August 8, 2022

Caivan (Orleans Village 2) Ltd.
2934 Baseline Road, Suite 302
Ottawa, ON K2H 1B2

Re: Environmental Noise Addendum Letter
Orleans Village (Phase 4), Ottawa
GW File No.: GW22-078 – Addendum Letter

FIGURE 2:
 STATIONARY NOISE: RECEPTOR LOCATIONS

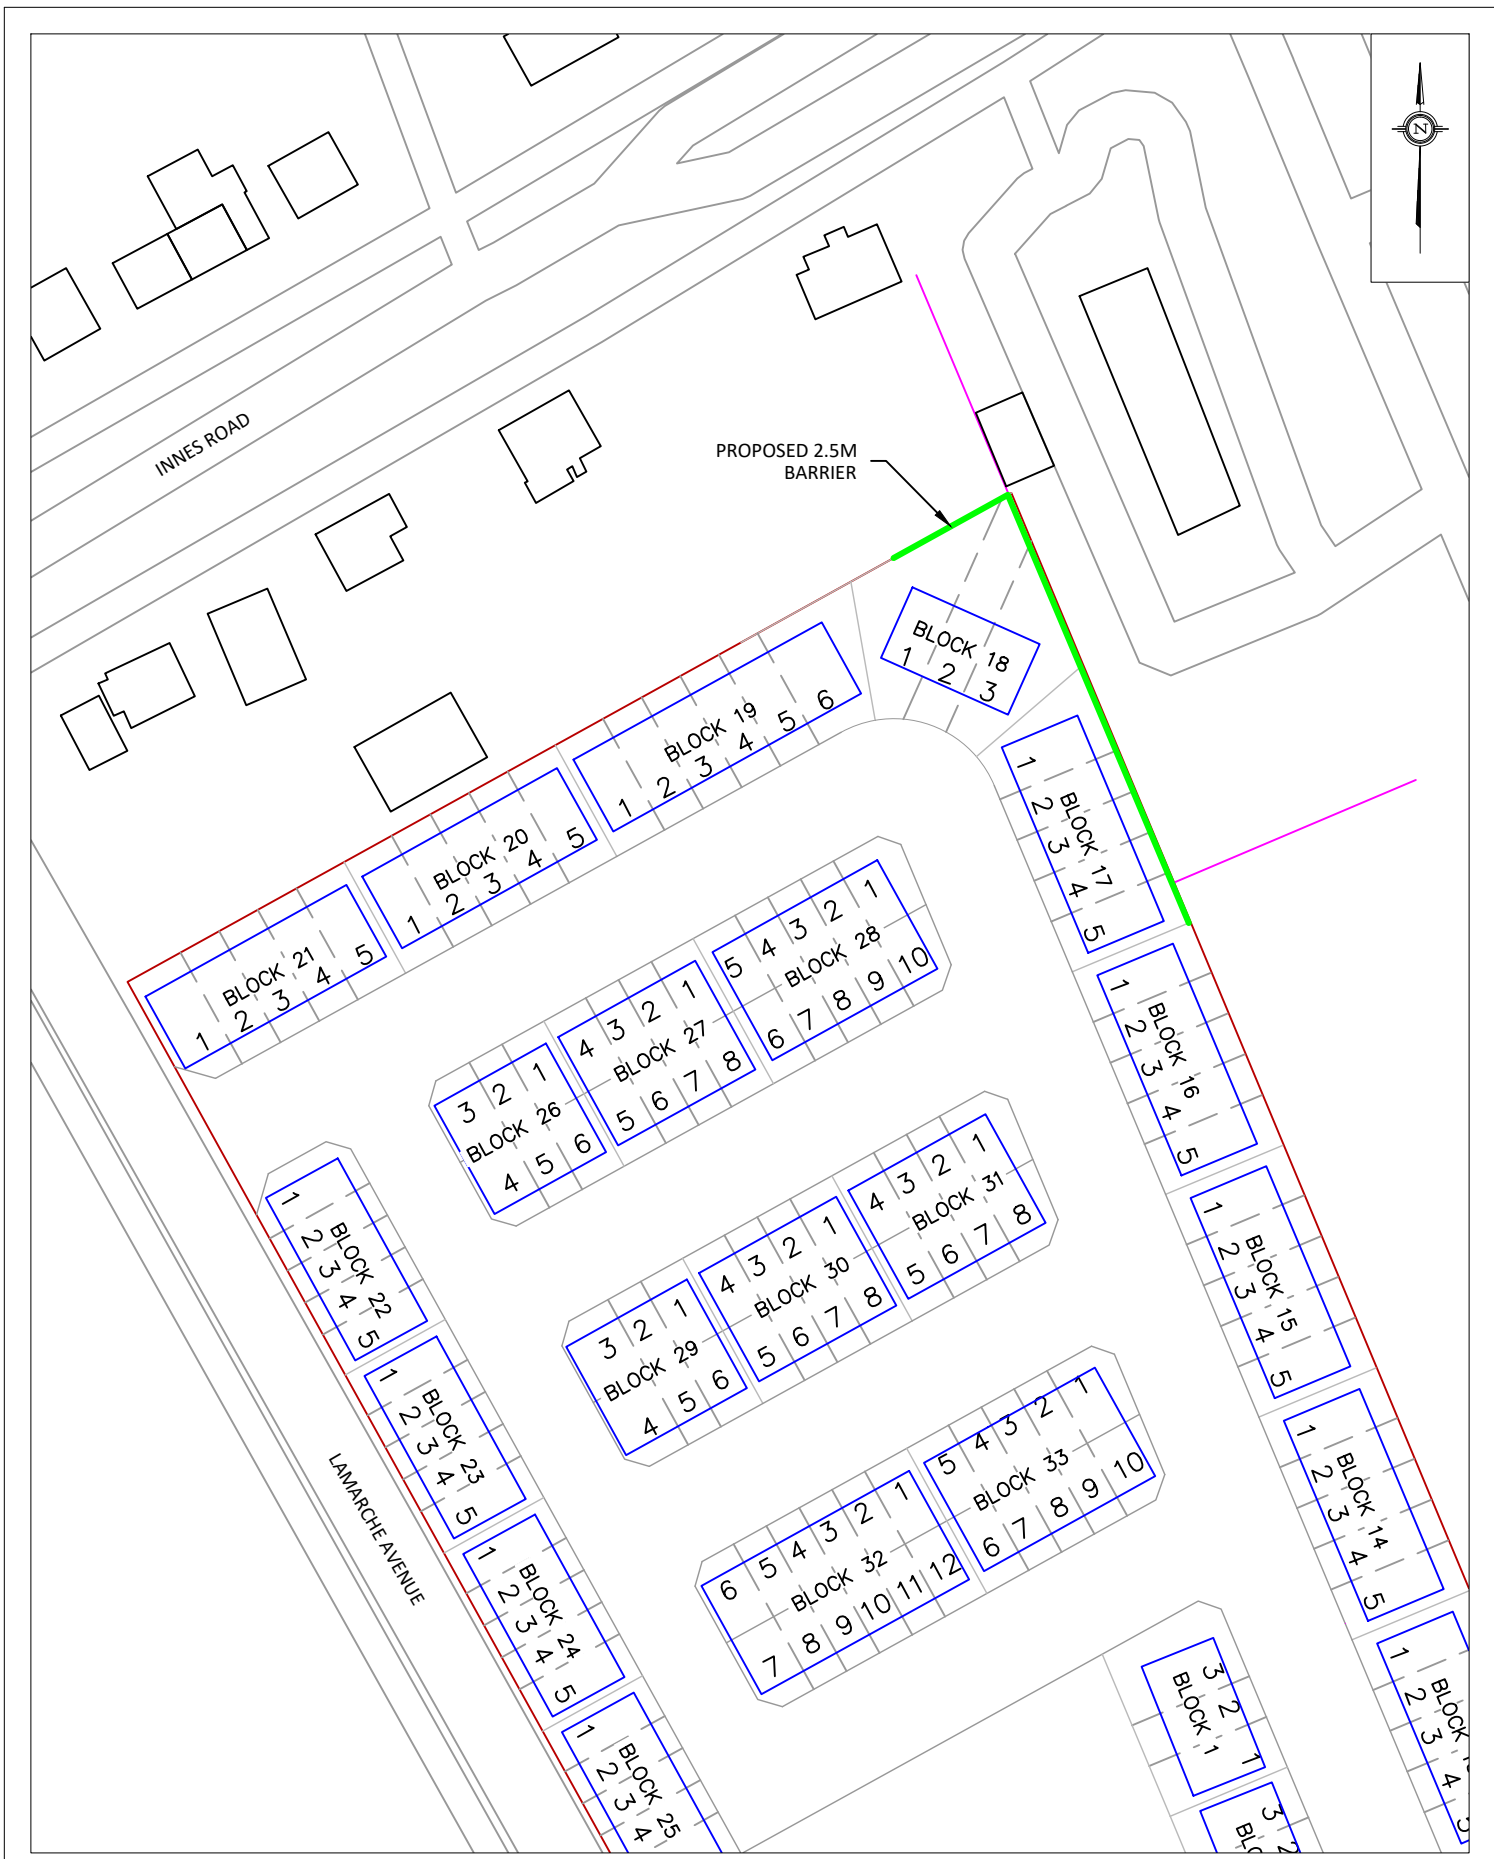
- 1. The noise study identified a 5m tall berm + noise barrier was required based upon the proposed site layout. Consideration should be made to:*
 - rearranging the subdivision lands to provide greater setbacks and result in a shorter required noise barrier, and/or;*
 - providing a different product type that would not include OLAs along the affected blocks. Note that it is the City's preference for mitigation measures that reduce the required height of the required noise barrier.*

- 2. Assess the land requirements on site to accommodate the grading of a 2.5m high berm (refer to berm setbacks within the City's Noise Control Guidelines), since the maximum barrier height that is acceptable is 2.5m. Ensure providing required barrier/berm height is feasible within the proposed block size. Alternatively, discuss the need for a retaining wall.*

As per the City's comments, Gradient Wind investigated the noise mitigating effects of implementing a 2.5 m tall noise wall/berm situated at the northeast corner of the property onto the development, primarily the rear yards. Noise receptors and the proposed barrier location are outlined in Figures 2 and 3, respectively. The proposed barrier length was also reduced such that it terminates at the boundary between Blocks 17 and 16.
